Westport Public Schools – Supply and Installation of Sound System Equipment for the Multi-Purpose Room at Greens Farms Elementary School

26-020-RFP-Addendum No. 1

EXHIBIT 2 – FirstLevel Floor Plan

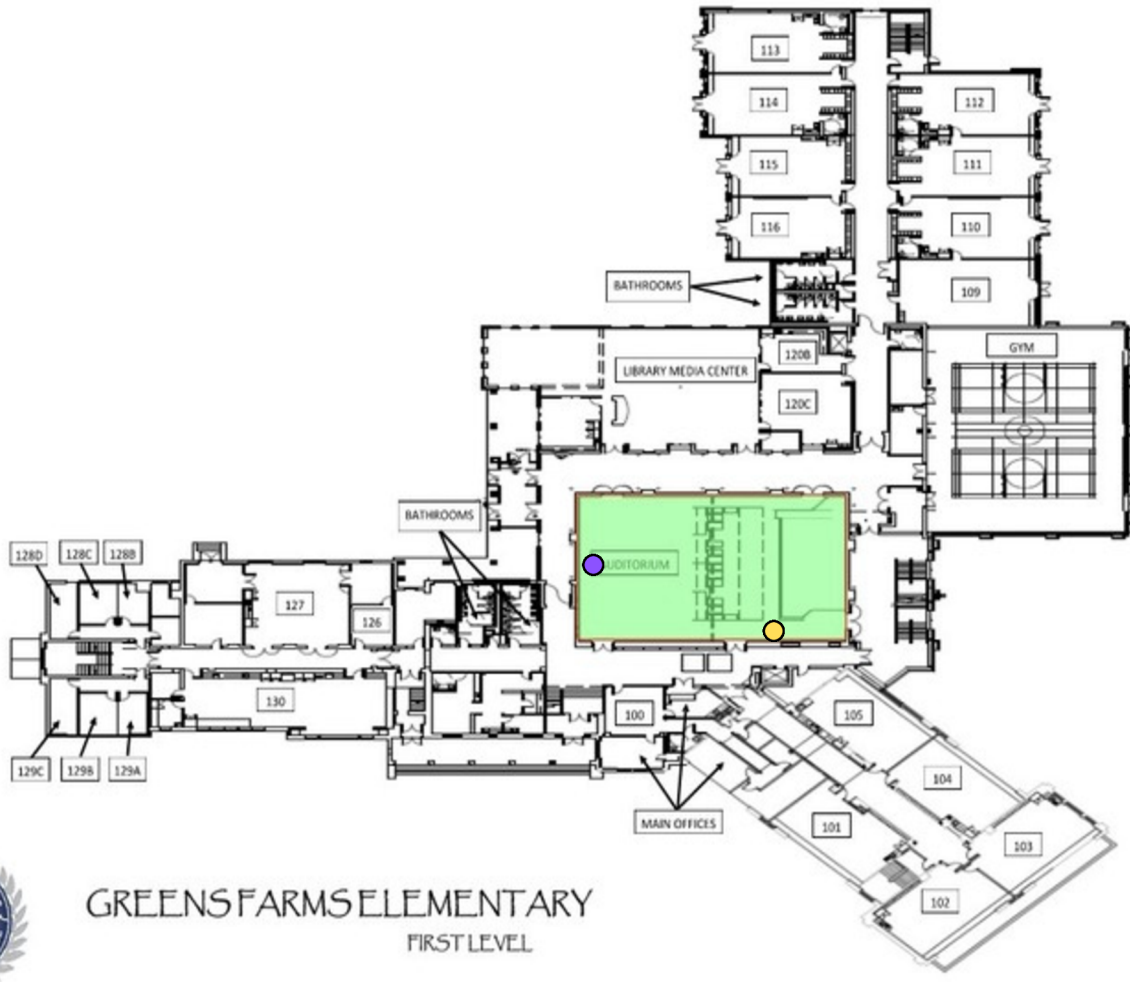
Where is the location of the “mix position”, which is also where the equipment rack will be located?

The primary “home” mix position and equipment rack location shall be located stage left against the wall, as indicated on the attached floor plan (yellow marker on plan). This location will house the rack-mounted equipment and serve as the default operating position during assemblies, concerts, and general use.

In addition, the district requires the ability to operate the mixing console from a secondary position located at the rear, center of the room (purple marker on plan) for theater use.

Due to the multi-purpose nature of the space, including the use of movable risers, the rear mix position shall not be permanently installed. Bidders shall provide a system design that allows for flexible operation of the mixing console from this rear location, including all necessary cabling, connectivity, and infrastructure to support temporary setup and full system functionality from that position.

Including the (2) placement indicators within room-refer to response #3 of Addendum #1
